GULMOHAR RESIDENCY

Details of Additions & Alterations

Flat No	Block no.	Type	Deluxe / Luxury
405	14		
Buyer Name	Phone No.	Email	
Mr. MVN ABHISHEK RAO M. S. RAGHAVENDRA RAO	8754640871

Description	Direction	Owners & Developers :	Date :	Promoted by
PLUMBING PLAN-1360 SF (A1-TYPE)		Mudi Reality Mallapur LLP	Prepared By :	Modi Properties Pvt Ltd Phone: +91-40-66333551
		Project Name & Phase :	Approved By :	
		Gulmohar Residency	Scale :	
			N.T.S

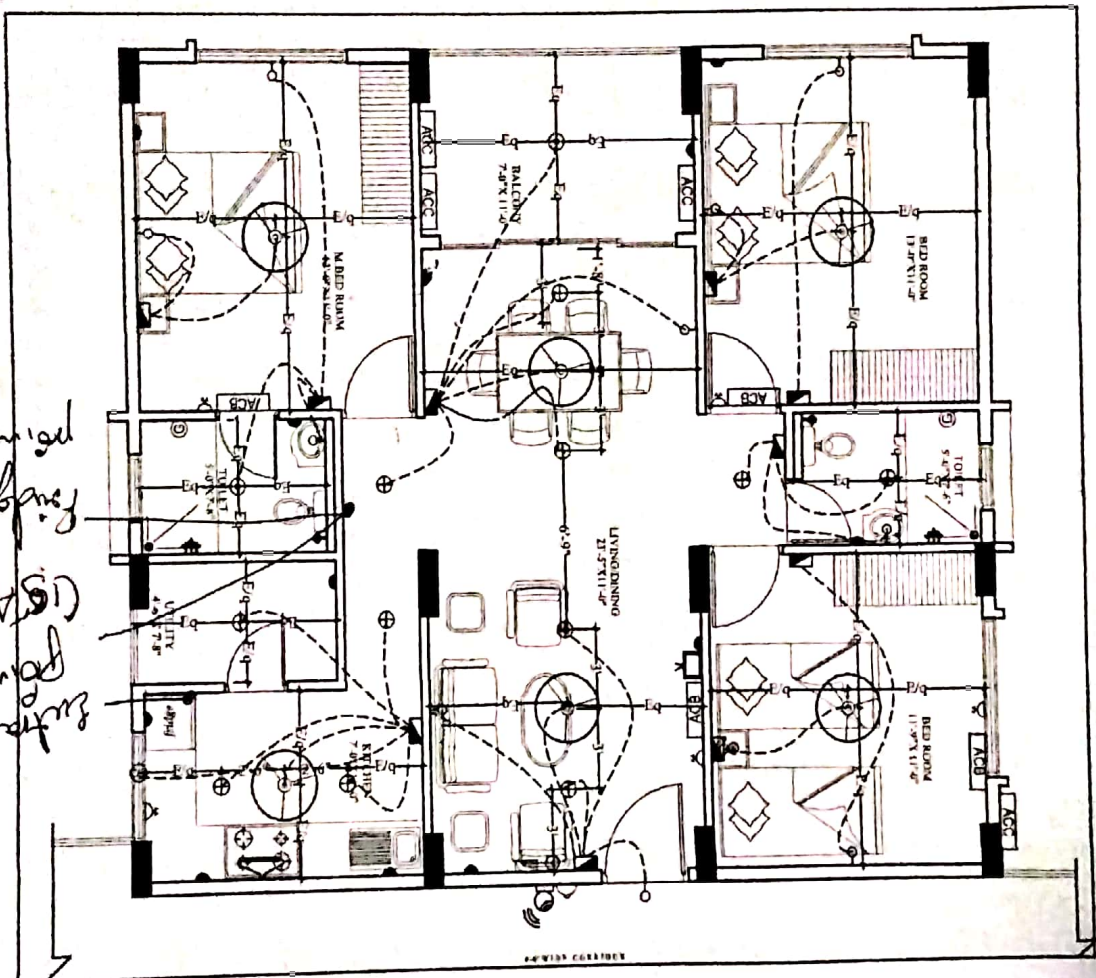
Choice of Bathroom tiles, CP fittings & Sanitary ware:
→ M/C top. should be 18" from tiles

→ Abak gade.

→ RCC slab form U shape & heavy in drawing.
24 Nov

DESCRIPTION	Direction	Owners & Developers:	Date:	Prepared By:	Promoted by:
ELECTRICAL PLAN - 1360 4B FLATS-A1 TYPE	N	Modi Realty Malindi LLP	21.09.2020	Jayaprakash	Modi Properties Pvt Ltd
		Project Name & Phase:	Approved By:	Sobhan Modi	
		Gulmohar Residency	Scale:	N.T.S	Phone:-91-40-66315551

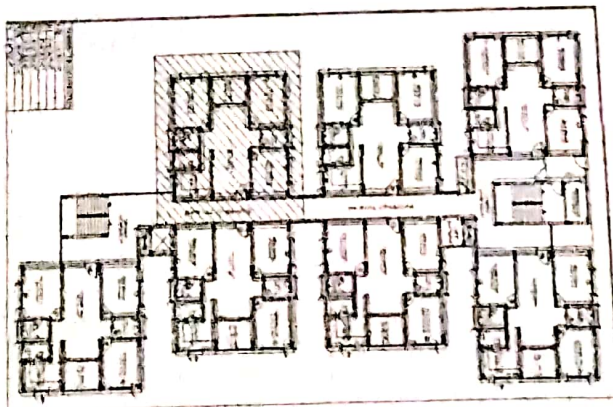
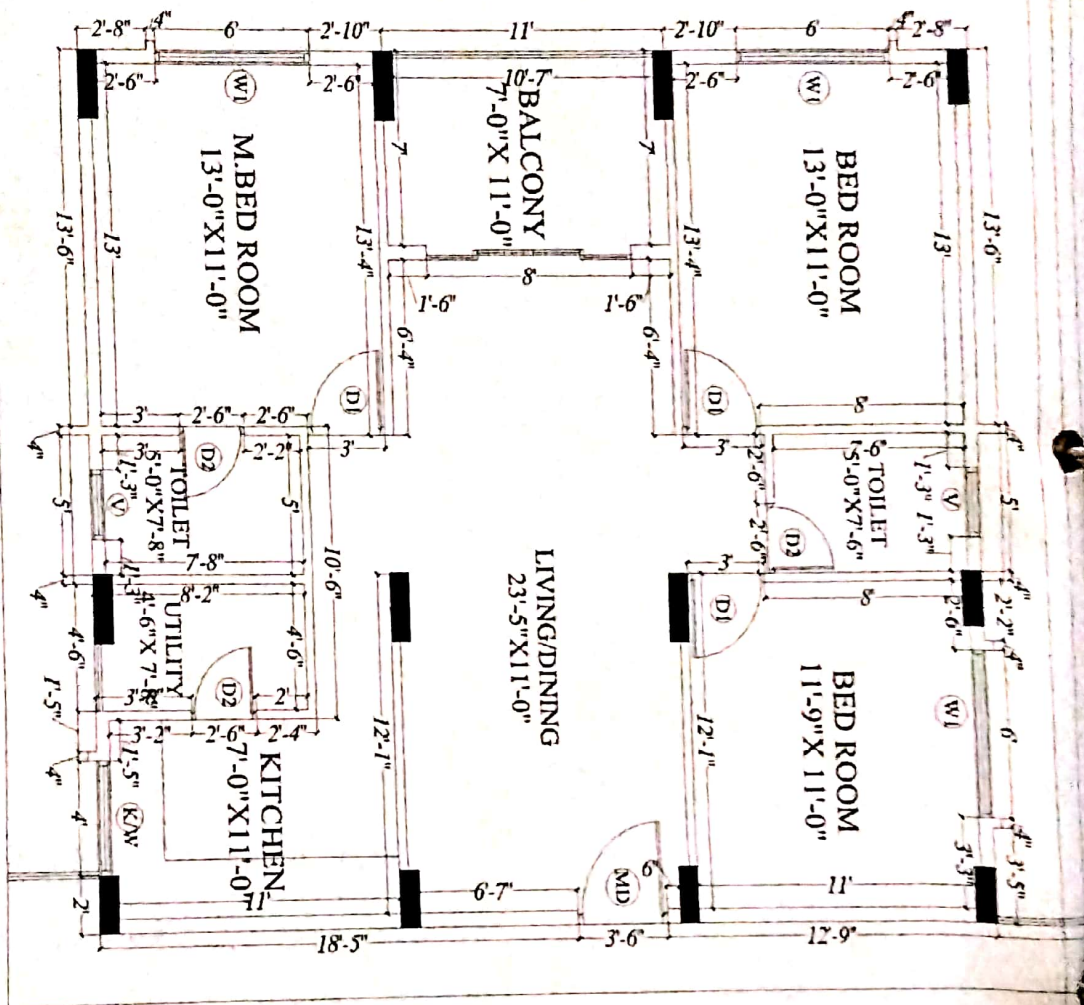
Changes in electrical points: (mark on plan)
→ Shown in plan for bridge, Over.

Bridge point
(15 Amp)
Extra point
